Re: Request for Access to Information under Part II of the Access to Information and Protection Privacy Act (the ATIPP Act, 2015)

All building files regarding 47 Harvey Road.

Re: **File #96-00488 (B-17-L.13)**
Proposed Mixed Use Building (2 Dwelling Units & Architectural Practice)
Civic #50-52 Long's Hill

Re: **50-52 Long's Hill**
2 Dwellings & Home Occupation
File # B-1-97-0021

Drawing Title
REVISED BASEMENT PLANS

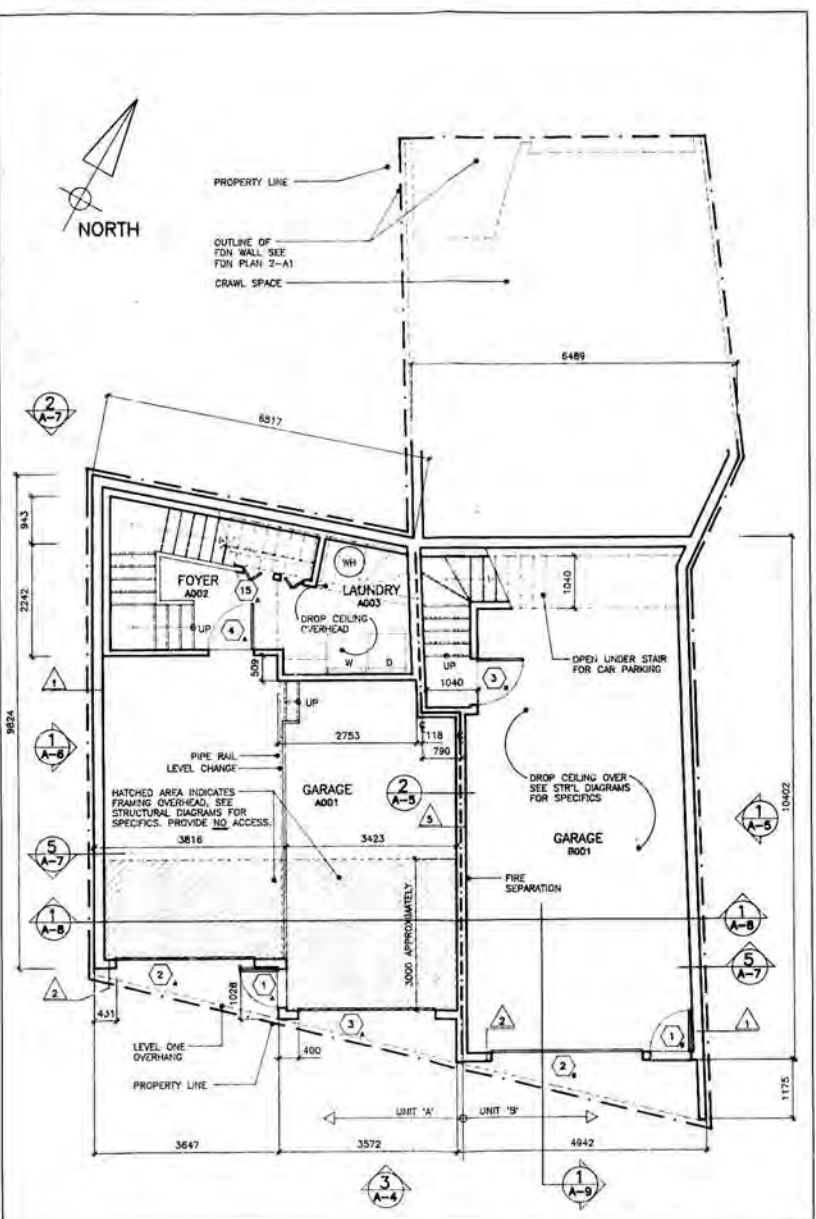
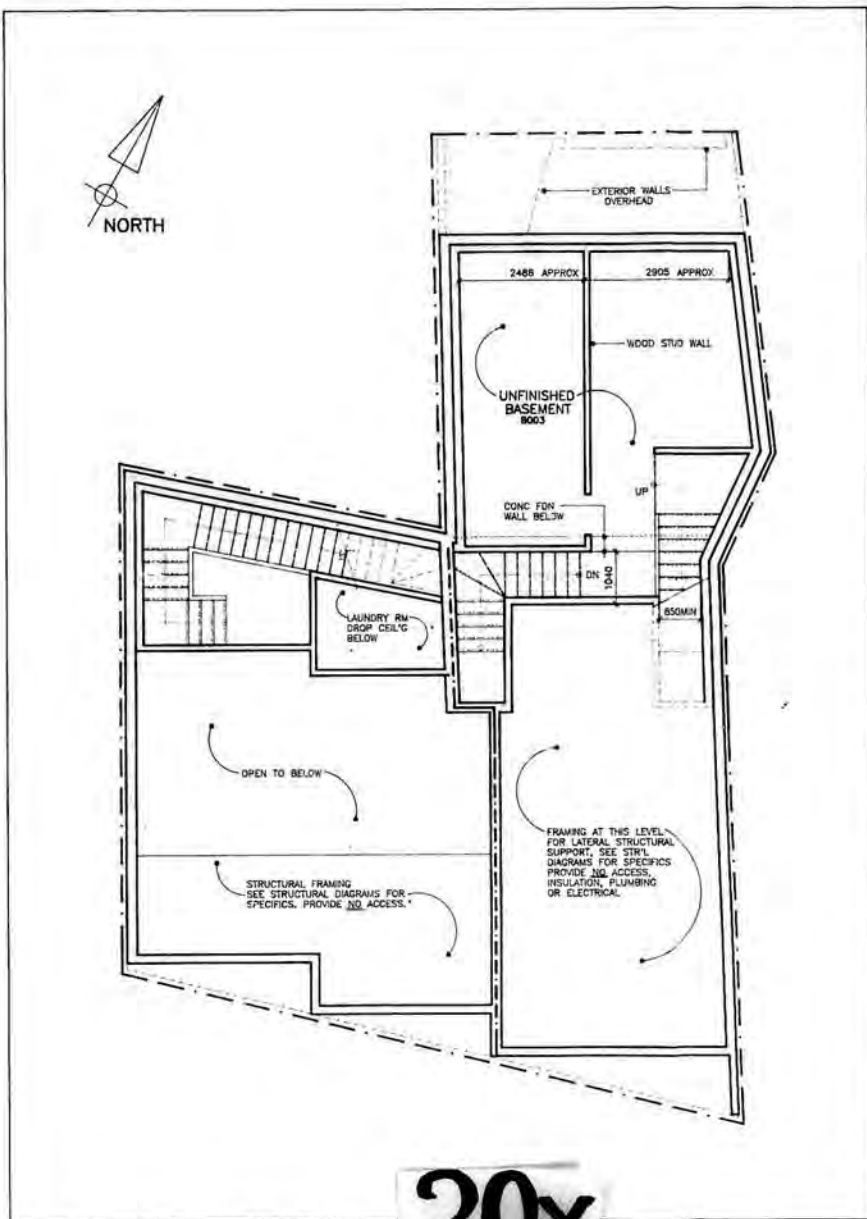
As per the request of Mr. Rick Kavanagh, the inspector assigned to my project at #47 Harvey Road, I am supplying you with information outlining the alterations made to the original plans due to the change in elevation between the sidewalks at Long's Hill & Harvey Road.

Upon excavation my structural engineer, Mr. Roy Pieroway, Design Services Ltd., advised me to not extend the garage /basement to the property boundary at Harvey Road so as not to undermine the existing rubble wall supporting the sidewalk there. The existing grade was maintained and this meant a concrete floor slab was poured at the top of the first set of stairs coming up from the garage in Unit 'B' (see 2-A2, Upper Basement Plan Revised).

Unexpected additional height was also encountered between the two streets. This required me to provide additional horizontal framing to provide lateral support for the building. In Unit 'A' this translated into framing over the garage doors and in Unit 'B' the full length of the garage was provided with framing at half way up its full height. **No** access is being provided to either of these spaces and they are being kept completely outside the building envelope. Units A & B are both being tested & registered R-2000 and for the energy budget to pass, these spaces are treated as exterior.

Enclosed please find design sketches from Mr. Roy Pieroway and a revised drawing, A-2.
